UNITED STATES PATENT AND TRADEMARK OFFICE

10/505,408

Office Action Summary	Application No. 10/505,408	Applicant(s) SATO ET AL.	
	Examiner Korie H. Chan	Art Unit 3632

DETAILED ACTION

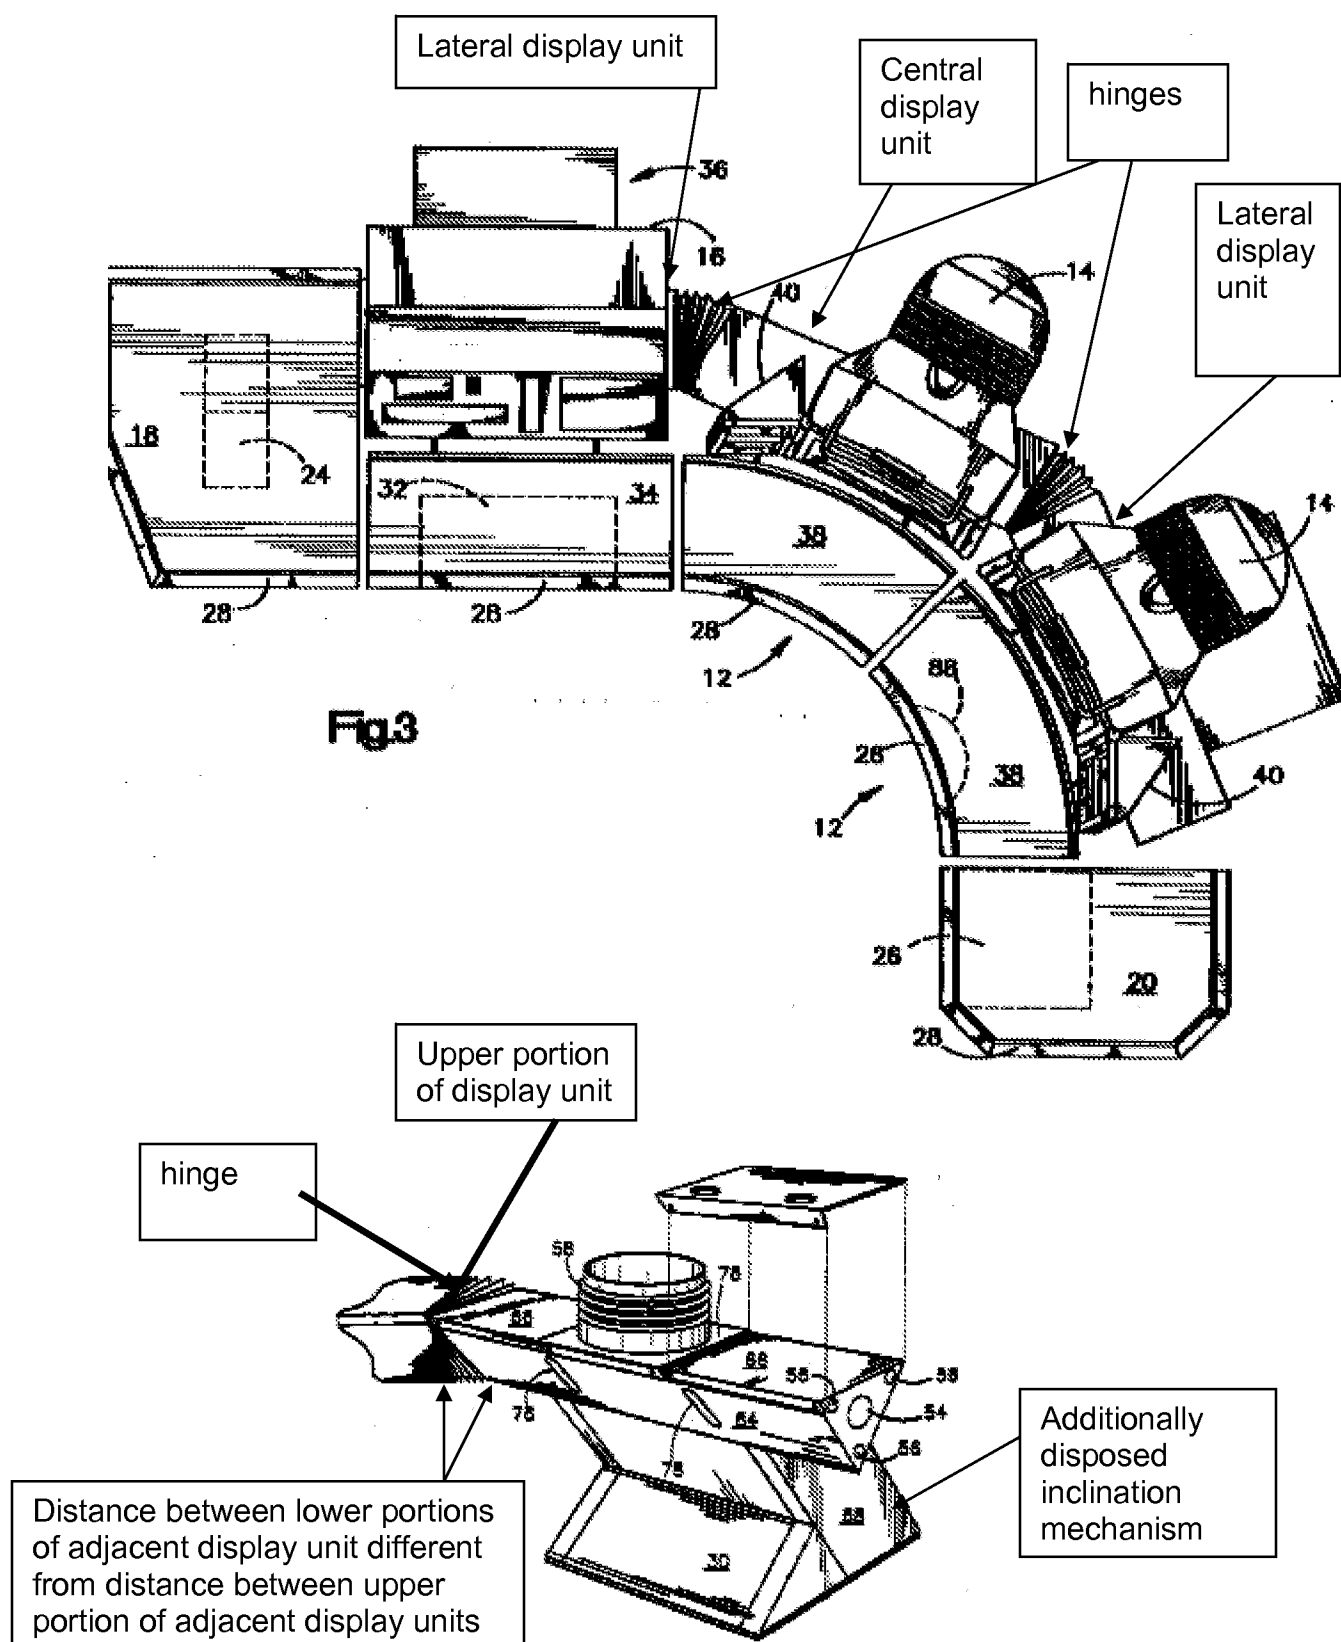
Claim 1 is rejected under 35 U.S.C. 102(e) as being anticipated by Fowler et al (US patent no. 6,302,612). Fowler discloses a multi-display device, wherein a plurality of basic displays or basic units are horizontally arranged, a central basic display or central basic unit (131) is supported and held in an inclined state by an additionally disposed inclination mechanism (the ball underneath central screen 131 connected to

the keyboard), lateral basic displays or lateral basic units (148) are connected to the central basic display or central basic unit (131) respectively by hinge members (ball and socket joint 147) so that a distance between the adjacent basic displays or basic units at an upper side portion of the basic display or basic unit is different from one at a lower side portion (the universal joint 147 of Fowler permits such distance to be different).
